THE CITY OF KEY WEST PLANNING BOARD Staff Report

То:	Chairman and Planning Board Members		
Through:	Katie P. Halloran, Planning Director		
From:	Scarlet Hammons, AICP CTP		
Meeting Date:	April 20 ^t , 2023		
Agenda Item:	Variance - 1617 Bahama Drive (RE# 00070240-000000) - A request for a variance to the minimum allowed side setback requirement and to exceed the maximum building coverage for a pool house and pool deck at a residence in the Single Family (SF) zoning district pursuant to Sections 90-391 through 397 of the City of Key West Land Development Regulations.		
Request:	The applicant is proposing to replace and enlarge an accessory structure in the rear of the property and to construct a pool deck. The applicant is requesting variances from the Land Development Regulations for properties zoned SF, to exceed the allowable maximum building coverage and side setback.		
Applicant:	Joshua Baeten		
Property Owner:	Joshua Baeten		
Location:	1617 Bahama Drive (RE# 00070240-000000)

Proposed Site Plan:

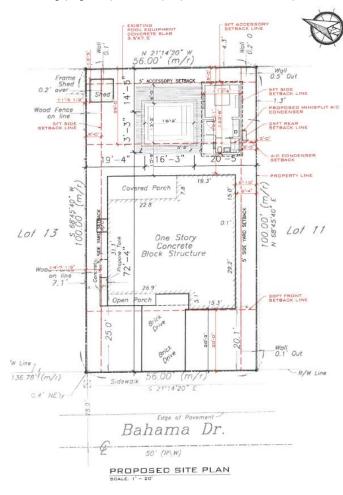
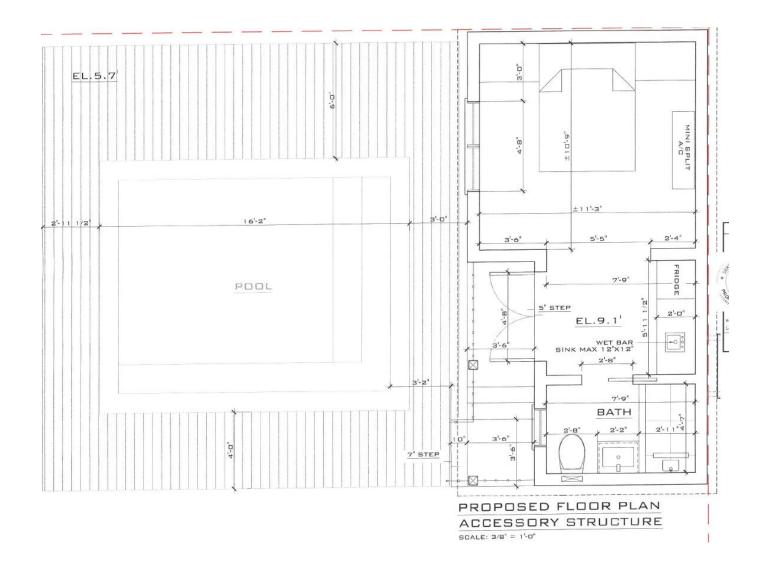
<u>Karen DeMaria:</u> I have no direct comment regarding the variance. Google Earth does indicate some tree/palms might be in or near the proposed work areas so a tree protection plan might be needed if and when demo/building permits are submitted.

The applicant requires a setback variance because the mini split air conditioner will have noncomplying setbacks. The rear and north side setback are in compliance as shown in the proposed site plan below. The image the following page depicts the proposed interior floor plan for the new accessory structure in the rear.

If the Planning Board chooses to approve the variances, the Planning Department recommends the following conditions:

- 1. The proposed construction shall be consistent with the signed and sealed plans prepared by Artibus Design Engineering and Planning and dated November 26, 2022.
- 2. Submit a tree protection plan when demolition permits are submitted.
